# Planning Approval Consistency Assessment Form

<b>Assessment Name:</b>	Hunter Street Station undercut and turnback tunnels
<b>Prepared by:</b>	Jacobs / Arcadis / Ethos Urban / Sydney Metro
<b>Prepared for:</b>	Sydney Metro West
<b>Assessment number:</b>	SMW05
<b>Type of assessment:</b>	Assessment under EP&A Act 1979, Division 5.2
<b>Version:</b>	Final
<b>Planning approval No. (where relevant):</b>	SSI - 19238057
<b>Date required:</b>	October 2022
<b>iCentral number</b>	SM-22-00366401

## 2. Description of proposed change which is the subject of this assessment

Figure 1 Location of proposed permanent undercut relative to the Approved Project

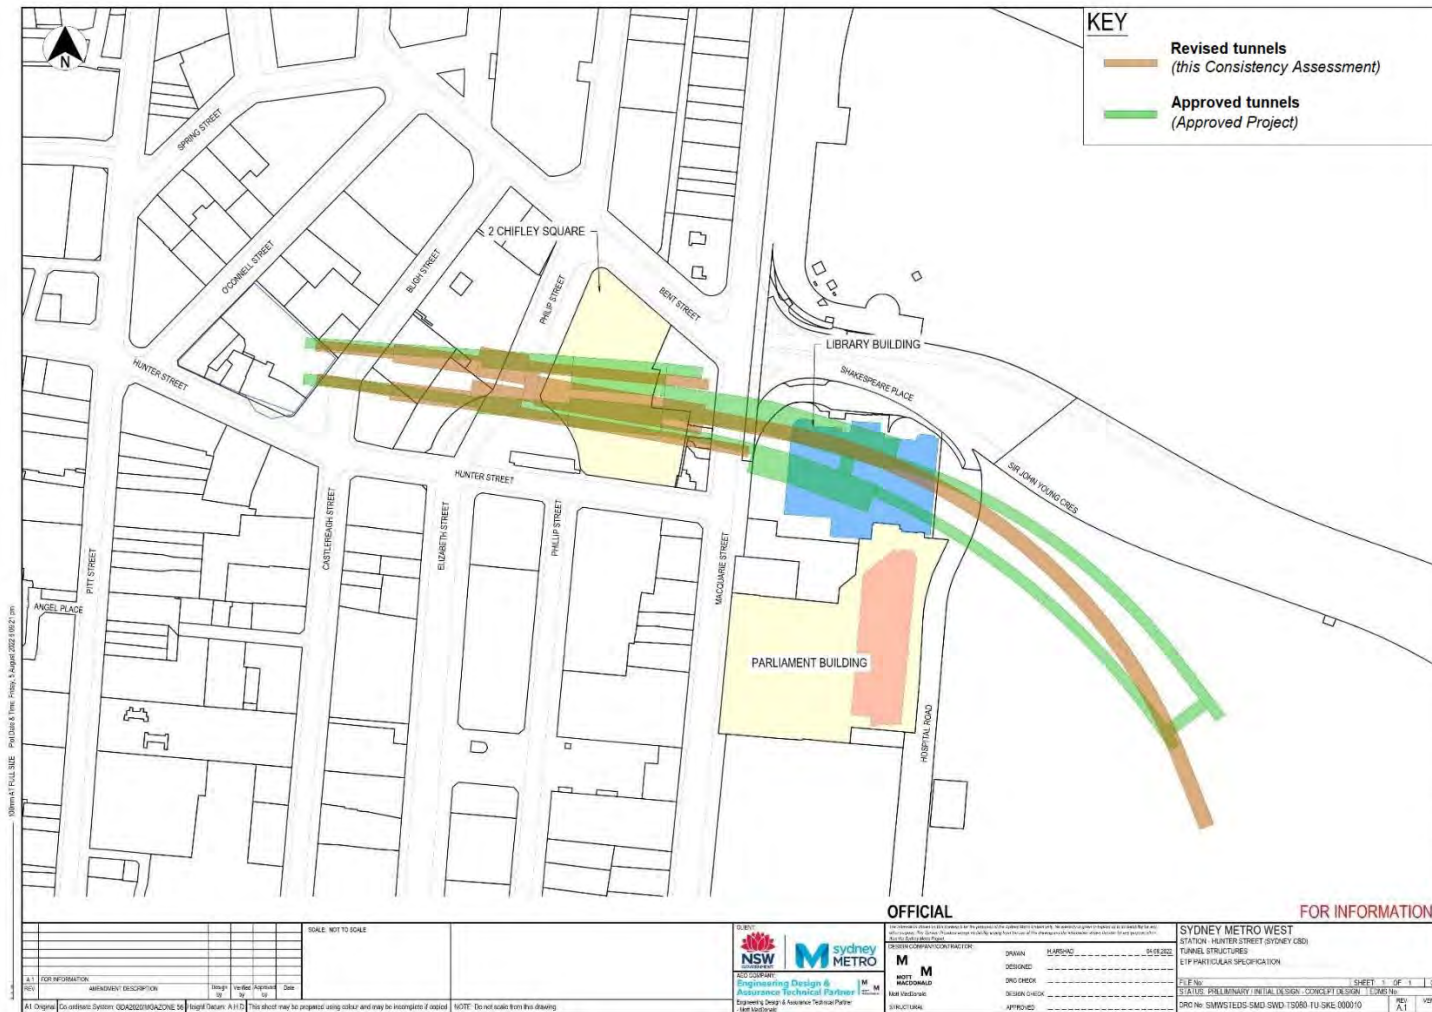
- Hunter Street Station (Sydney CBD) construction site undercut – An additional substratum excavation adjoining the Hunter Street Station (Sydney CBD) eastern construction site shaft that would be located partially outside the Approved Project corridor, under the Hunter Street road reserve, as shown in Figure 1. This undercut would remain as a permanent excavation required to support operation of the future Hunter Street Station (CBD).

Figure A-1: Location of proposed permanent undercut relative to the Approved Project

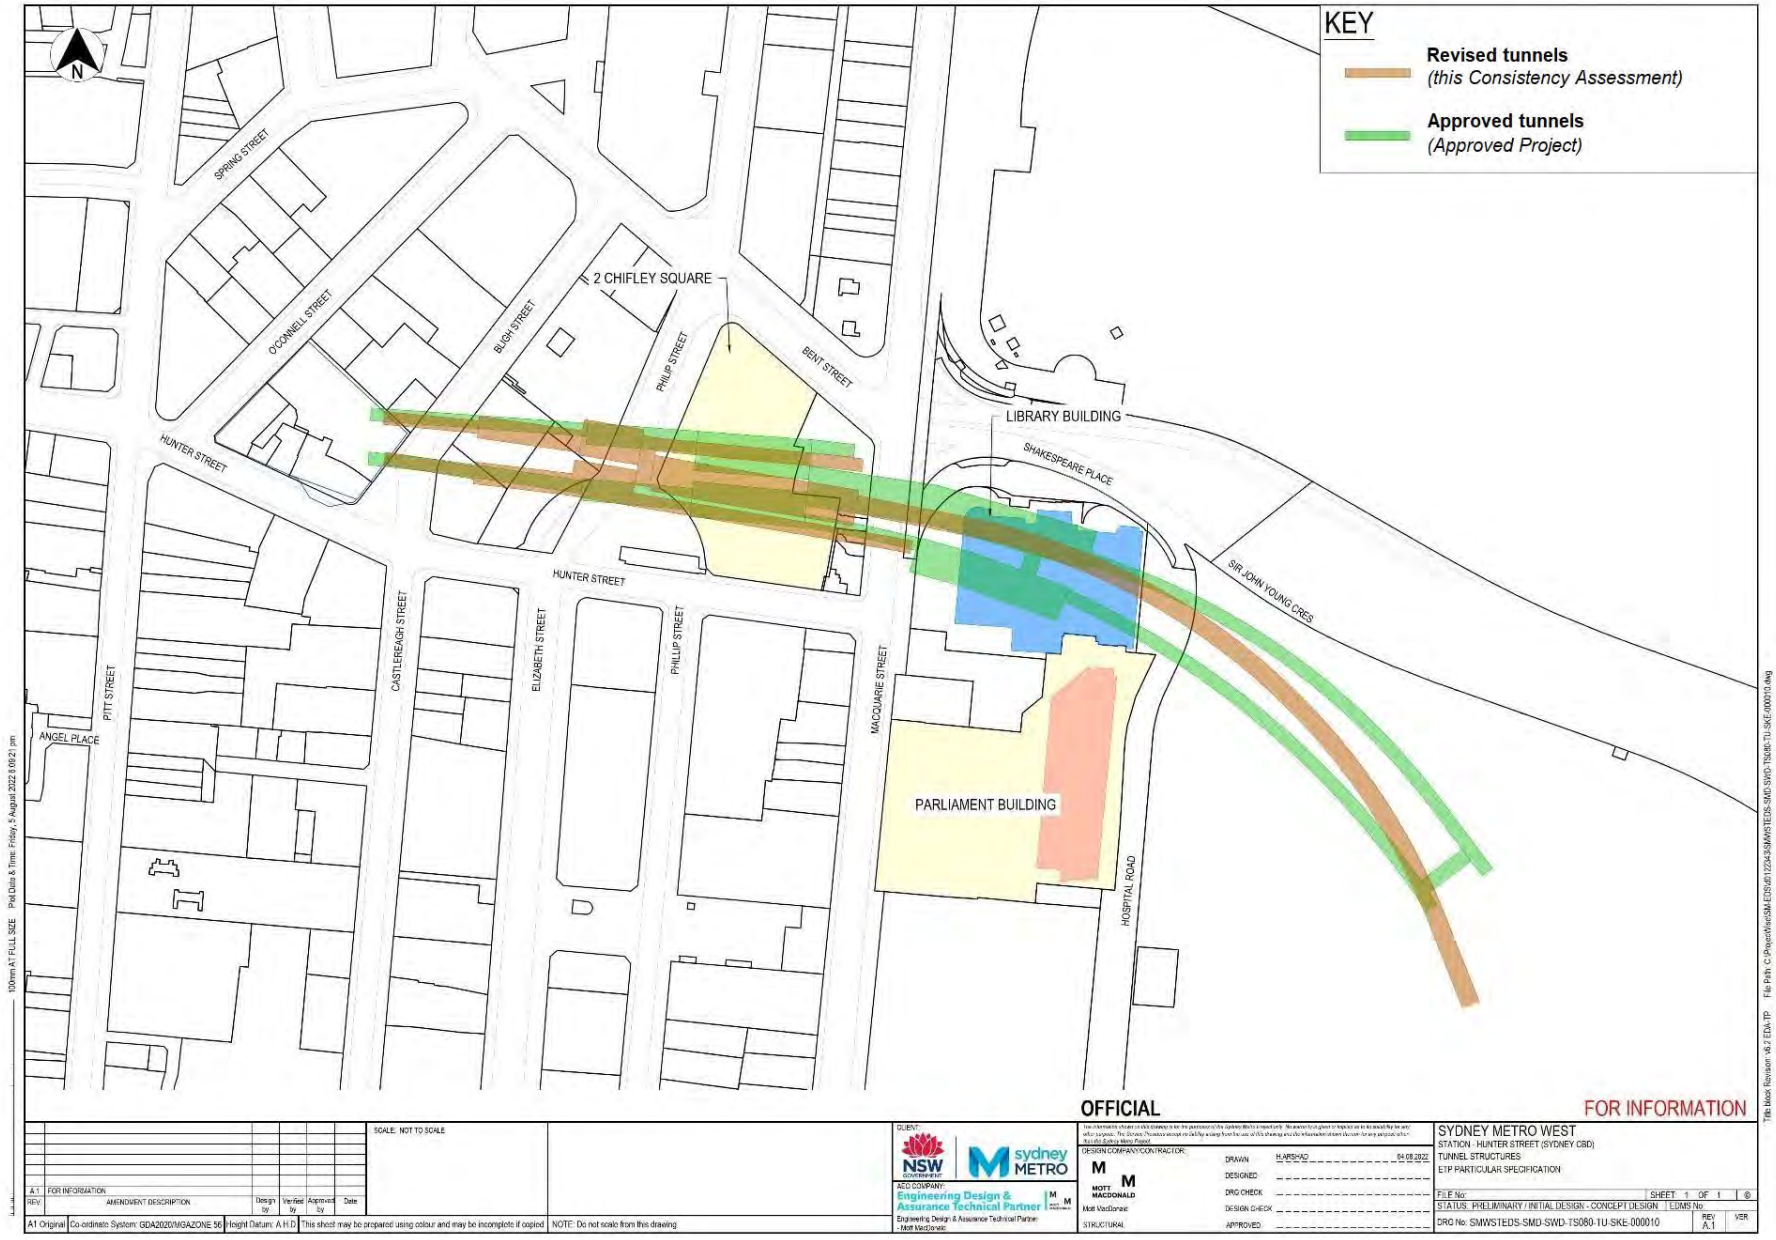
- Revised alignment of the turnback tunnels from Hunter Street Station (Sydney CBD) to The Domain. The proposed change in tunnel alignment is located entirely underground and the depths of the realigned tunnels would be similar to the relevant sections of the approved tunnel alignment as shown in Figure 2. The proposed realignment of the turnback tunnels would generally be within the Approved Project corridor, with the end of the tunnels extending past the approved corridor under The Domain. The realigned tunnels would not be located under any private properties that were not previously identified within the EIS.

**Figure 1 Revised Tunnelling – Hunter Street Station (Sydney CBD) Construction Site**

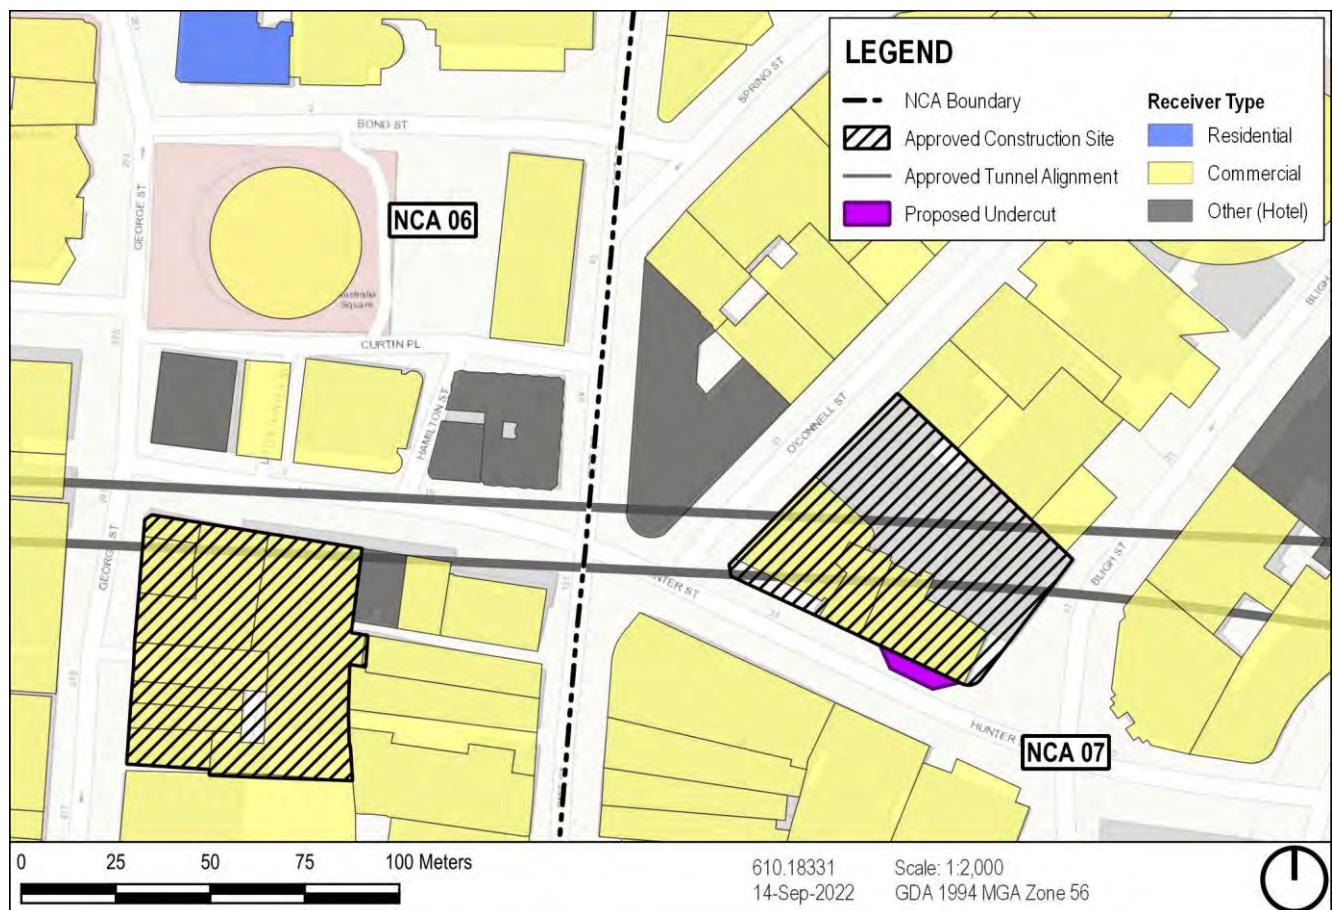
- The inclusion of an additional substratum excavation adjoining the Hunter Street (Sydney CBD) east shaft. This undercut would remain as a permanent excavation required to support the operation of the station.
- Revised alignment of the turnback and stub tunnels from Hunter Street Station (Sydney CBD) to The Domain. The proposed change in tunnel alignment is located entirely underground and the depths of the realigned tunnels would be similar to the relevant sections of the approved tunnel alignment. The southern stub tunnel would be shortened by around 300 metres and all tunnel elements are generally more distant from sensitive receivers compared to the approved project alignment.

**Figure 2 Revised Tunnelling – Hunter Street Station (Sydney CBD) to The Domain**

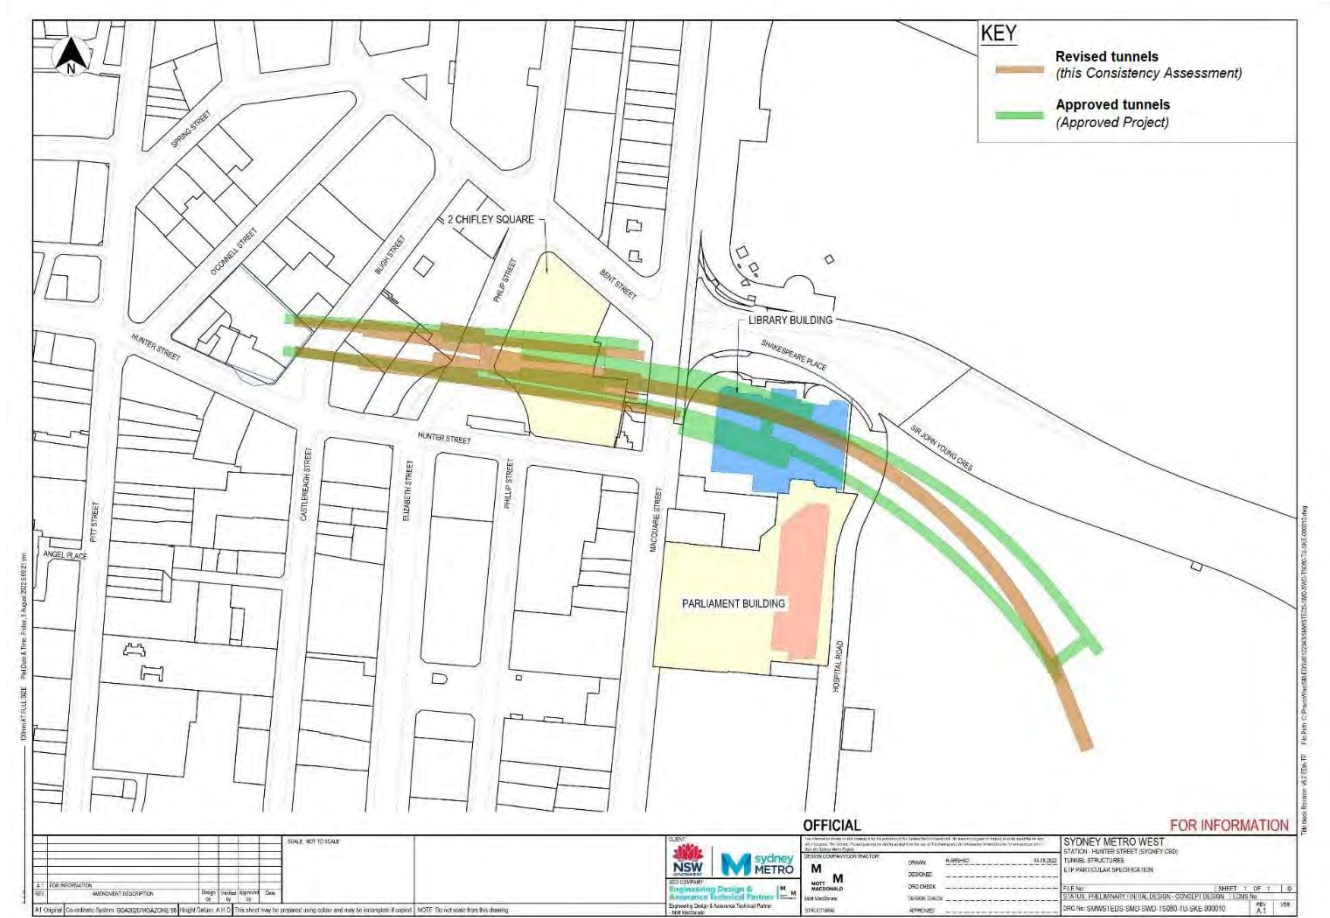
The revised tunnel alignment east of Hunter Street Station (Sydney CBD) to The Domain is shown in **Figure 2** and compared to the approved tunnel alignment.

The closest section of the revised tunnels is generally more distant from sensitive receivers compared to the approved tunnels, as shown in **Figure 2**. The depths of the realigned tunnels would be consistent with the approved tunnel alignment, such that the total 3D slant distance between the proposed tunnels and the sensitive receivers is also generally more distant compared to the approved project.

Figure 1: Proposed change to Hunter Street eastern construction site (Source: Sydney Metro)

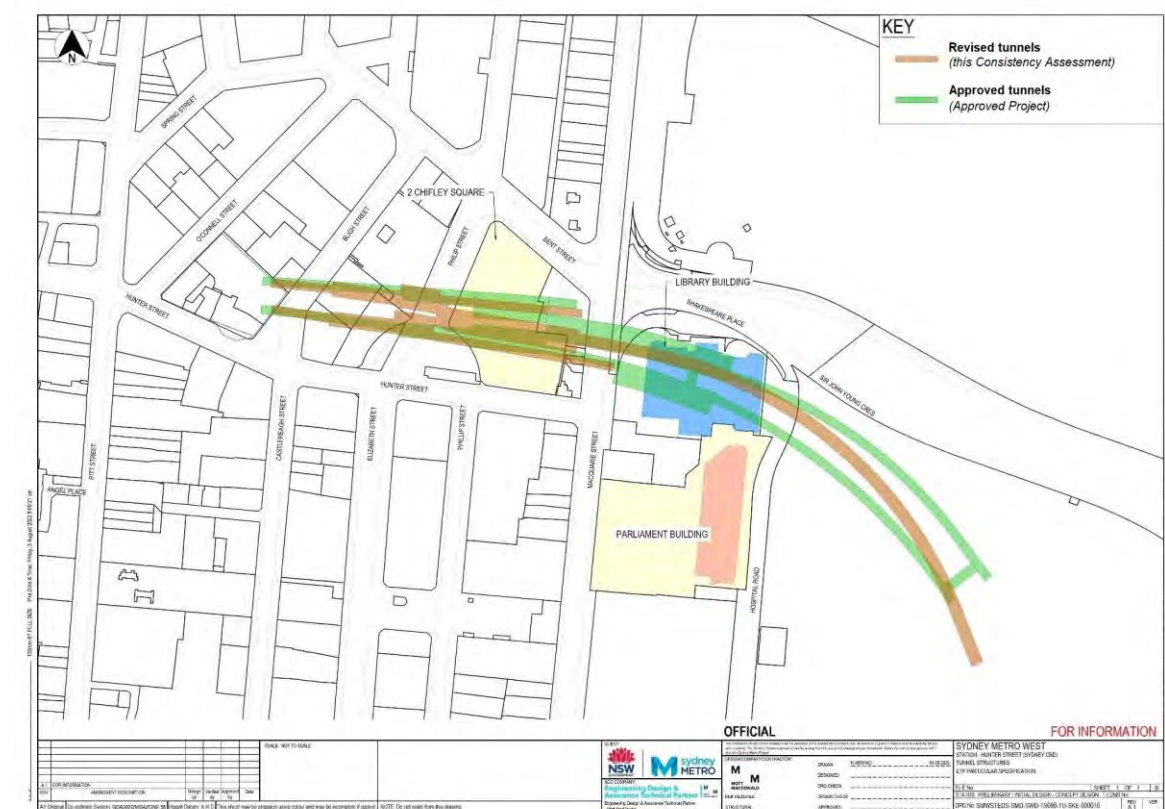
- Hunter Street Station construction site undercut – An additional substratum excavation adjoining the Hunter Street Station eastern construction site shaft that would be located partially outside the approved project corridor. This undercut would remain as a permanent excavation required to support operation of the future Hunter Street Station.
- Revised alignment of the turnback tunnels from Hunter Street station to The Domain. The proposed change in tunnel alignment would be located entirely underground and the depths of the realigned tunnels would be similar to the relevant sections of the approved tunnel alignment. The proposed realignment of the turnback tunnels would be generally within the approved project corridor, with the end of the tunnels extending past the approved corridor into The Domain.
